LEBANON PLANNING BOARD
FEBRUARY 14, 2022 - 6:30 PM
COUNCIL CHAMBERS, CITY HALL OR
REMOTE VIA VIRTUAL PLATFORM
LEBANONNH.GOV/LIVE

A. **Mount Support Development, LLC (applicant) and Sylvia D. Lahaye Revocable Trust & Pat Lumber Jack, Inc. (property owners), 402 & 392 Mount Support Road (Tax Map 24, Lots 9 & 10), zoned R-1:** Request for Site Plan Review to construct a proposed 4-building multi-family development consisting of 204 dwelling units, together with parking, utilities, landscaping, access, and other related site improvements. PB2021-33-SPR - Continued from January 10, 2022

S:\PROJECTS\2019\19324.402 MT. SUPPORT ROW\SHEET FILES\19324 C2.7 UTILITIES PLAN.DWG

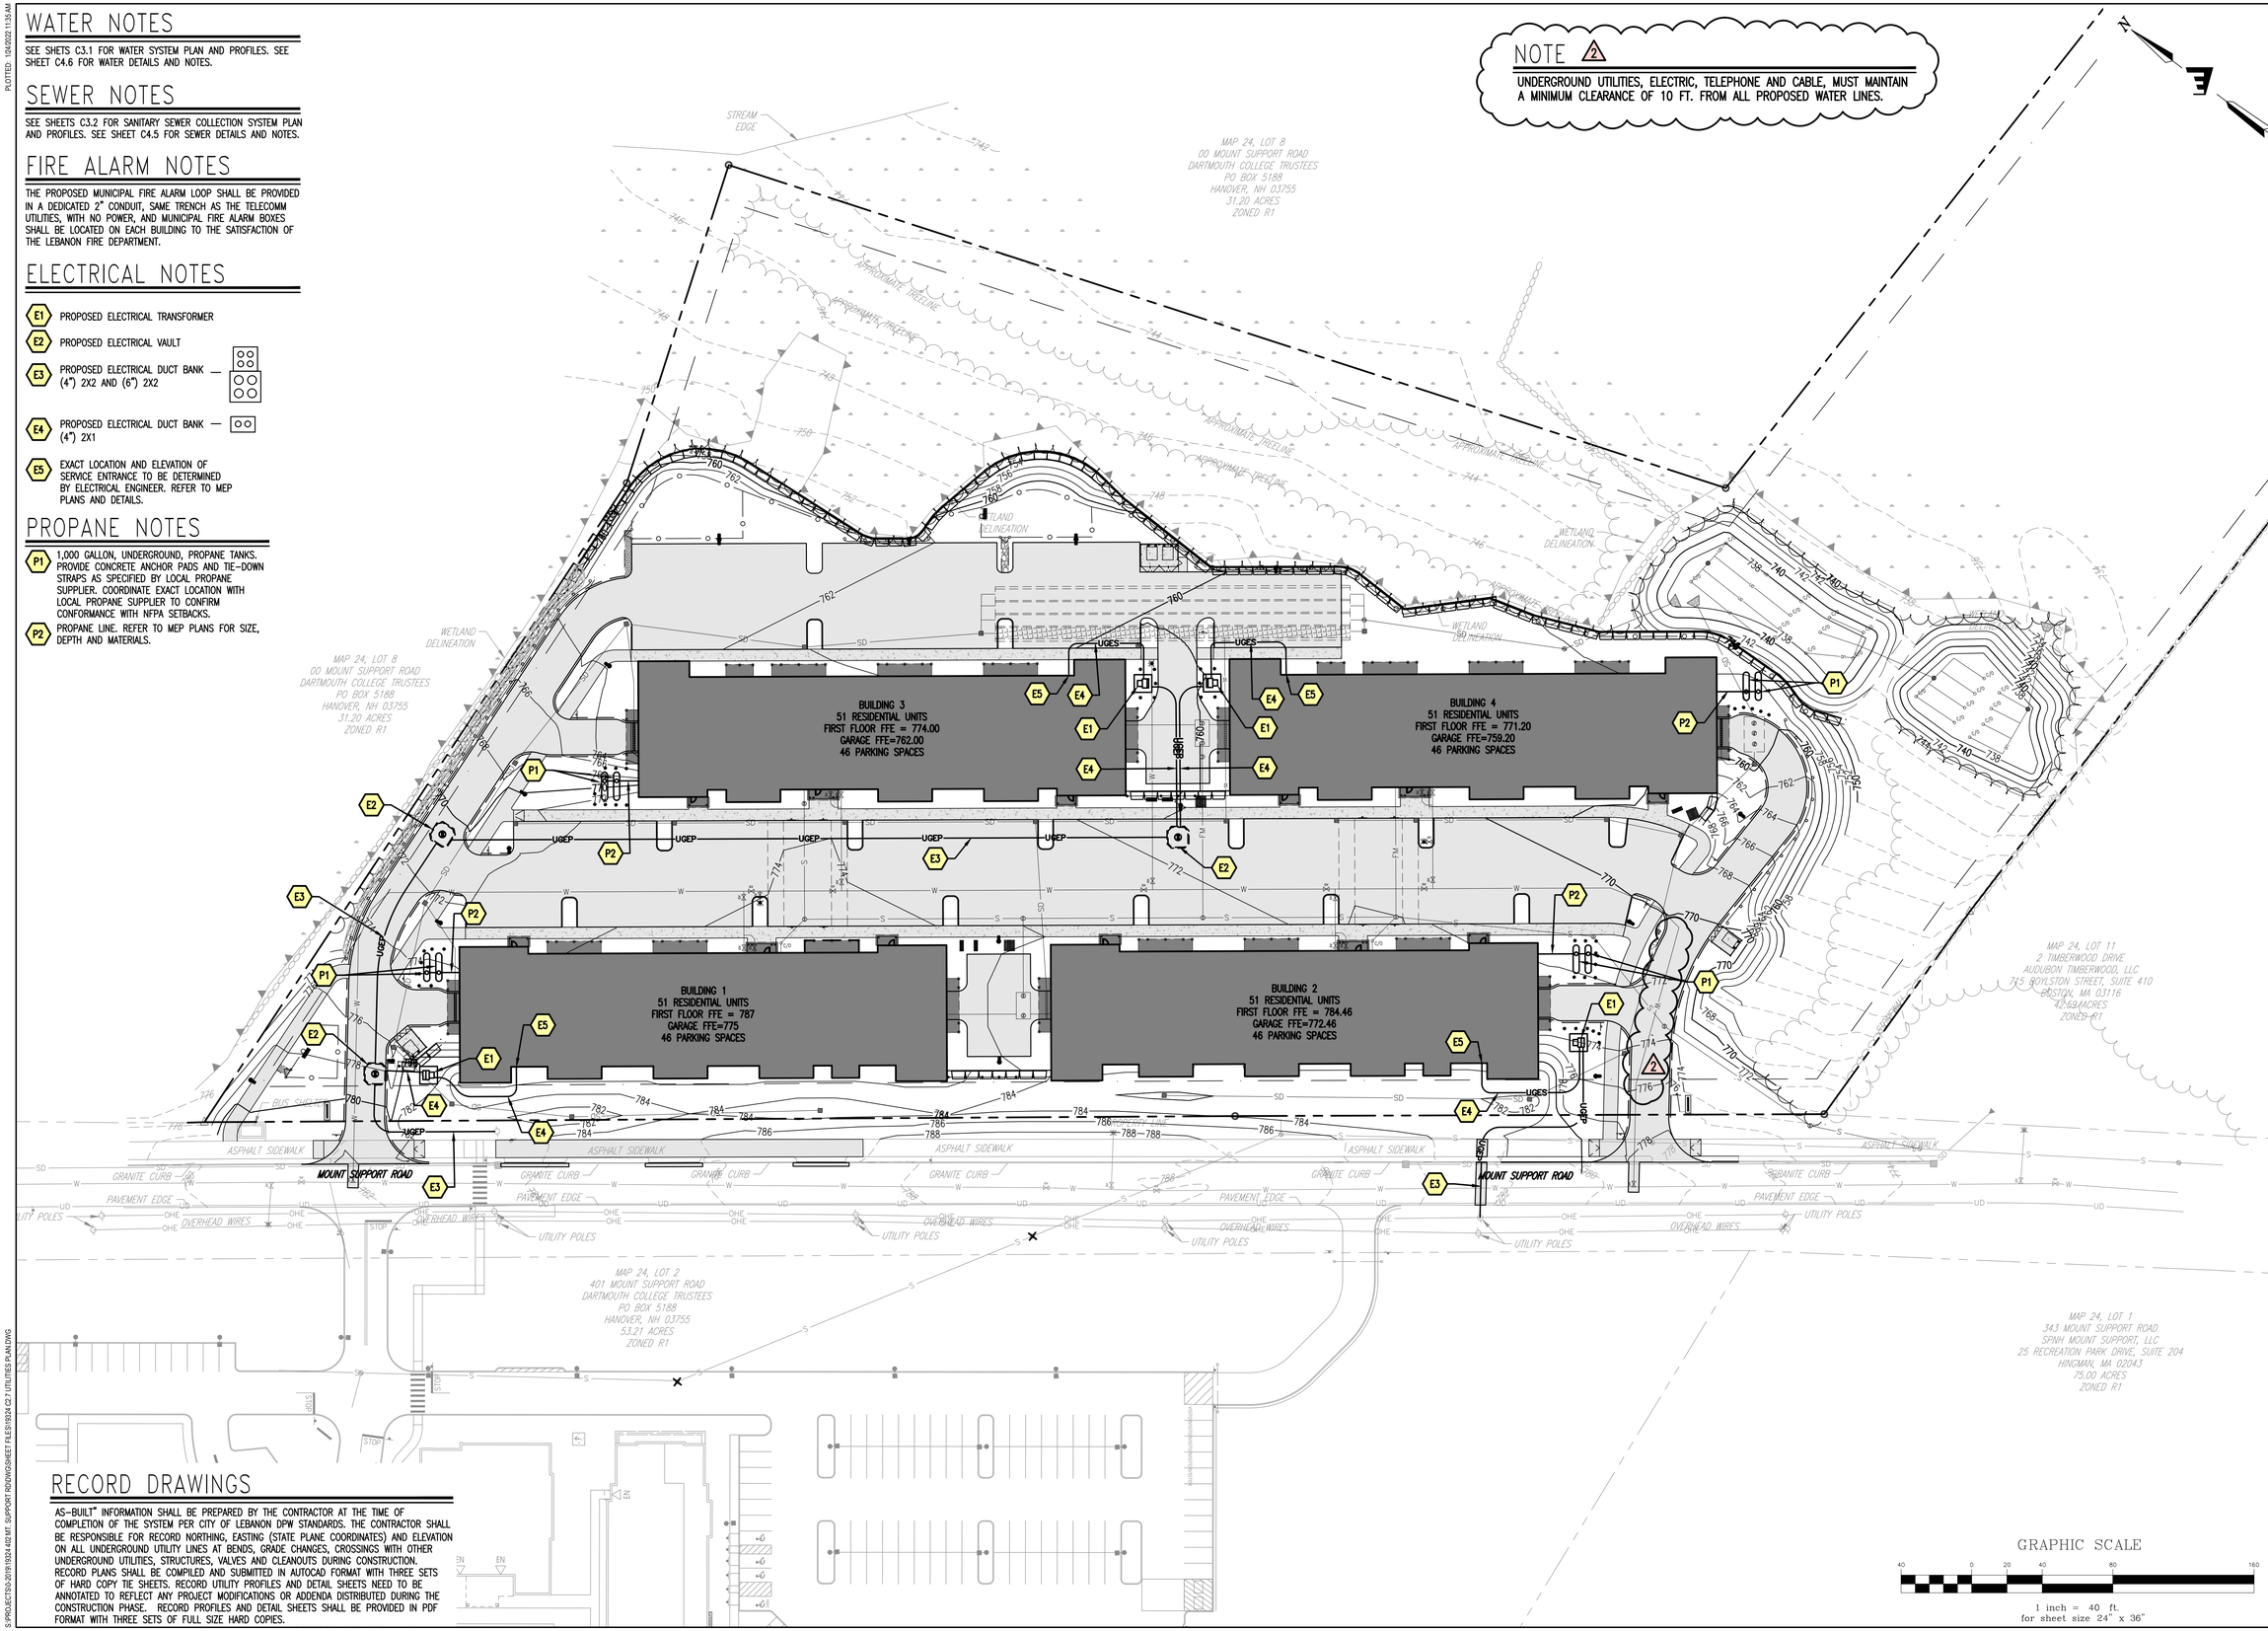
Proposed Condition 1. b): Amend Sheet 16 (Utilities Plan) to add a note indicating that underground utilities, electric, telephone and cable, must maintain a minimum clearance of 10 ft. from all proposed water lines.

- This resubmission package includes a revised Sheet 16 (C2.7) with the requested note. The project's utility designs maintain the requisite separation.

UNDERGROUND UTILITIES, ELECTRIC, TELEPHONE AND CABLE, MUST MAINTAIN A MINIMUM CLEARANCE OF 10 FT. FROM ALL PROPOSED WATER LINES.
